INDESIT company

BAN13S

F038160

51520g0 Exploded views

N1030093fig1

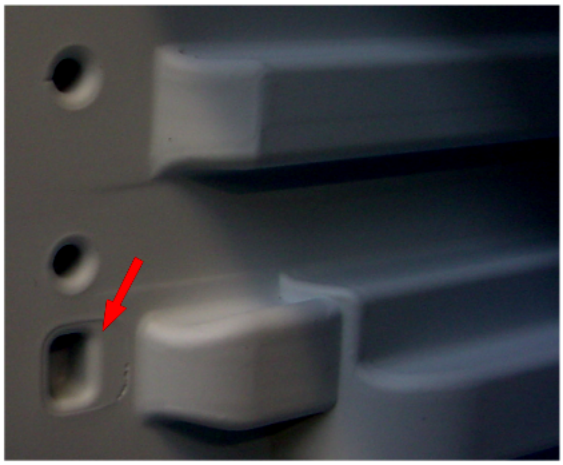
## n1030093: New fixing of evaporator on static fridge-freezers (05 range) 60 cm,Melano

From August 05 (serial no. 50802.0001) the freezer evaporator is secured to the cabinet by a plastic profile.
The cabinet walls have been modified to create locations to house the profile, which is installed on the front of each evaporator plate (see photo N1030093fig1- fig2 - fig3)
The profile cannot be fitted on premodification appliances, so technical personnel must continue to fit the rh and lh supports on these models (see photo N1030093fig4)

New parts
C00141135 = WHITE PROFILE L=443.5 MM

Parts replaced
C00075596 = EVAPORATOR RH SUPPORT
C00075597 = EVAPORATOR LH SUPPORT

N1030093fig1

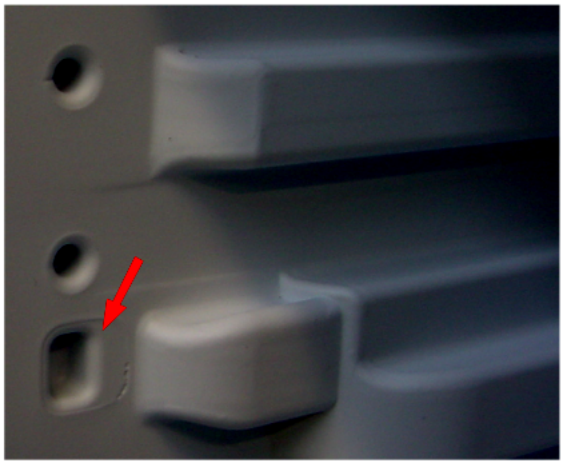
## n1030094: New fixing of evaporator on static fridge-freezers (05 range) 60 cm, Lodowek

From August 05 (serial no. 50820.0001) the freezer evaporator is secured to the cabinet by a plastic profile.

The cabinet walls have been modified to create locations to house the profile, which is installed on the front of each evaporator plate (see photo N1030093fig1- fig2 - fig3)
The profile cannot be fitted on premodification appliances, so technical personnel must continue to fit the rh and lh supports on these models (see photo N1030093fig4)

New parts
C00141135 = WHITE PROFILE L=443.5 MM

Parts replaced
C00075596 = EVAPORATOR RH SUPPORT
C00075597 = EVAPORATOR LH SUPPORT
